Manual Supplement

Manual Title:	789 Calibration	Supplement Issue:	4
Part Number:	1988891	Issue Date:	4/09
Print Date:	September 2002	Page Count:	2
Revision/Date:

Figure 2. Verifying Loop Power

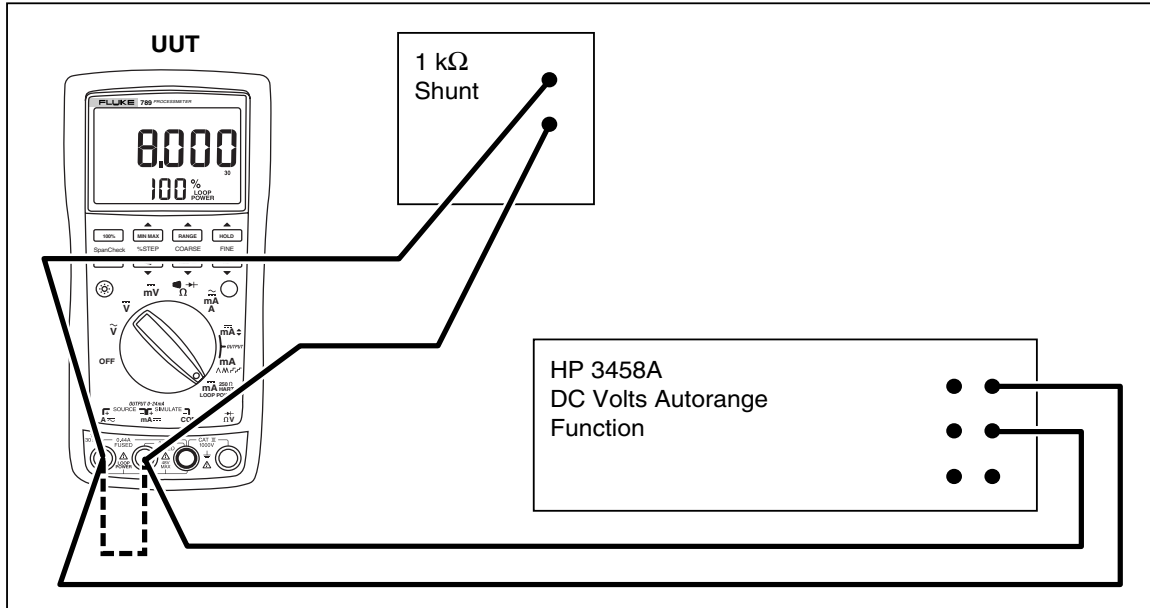
On page 12, replace the **Loop Power** procedure, and Figure 2 with the following:

1. Enable the dc volts autorange function of the HP3458A multimeter.
2. Turn the rotary knob of the UUT to **LOOP POWER**.
3. Measure the open circuit voltage of the UUT and verify it is greater than 29.8 V and less then 32 V.

4. Press the blue button on the UUT to enable the 250 Ω HART resistor.
5. Repeat step 3.
6. Disable the 250 Ω HART resistor by pressing the blue button.
7. Connect the 1-k Ω shunt across **SOURCE +** and **SOURCE -** of the UUT.

8. Measure the loaded down voltage and verify it is greater than 23.8 V and less than 32 V see Figure 2.
9. Remove the 1-k Ω shunt.
10. Disconnect the UUT from the multimeter and turn the UUT off.

11. Select the dc current function on the multimeter and set it to the 1-amp range (a 0.1 Ω shunt is used in the 1-amp range).
12. Connect the current input terminals of the multimeter to the **SOURCE +** and **SOURCE -** terminals of the UUT.

13. Turn the rotary knob of the UUT to **LOOP POWER**.
14. Verify the short circuit current is greater than 25 mA and less than 35 mA.
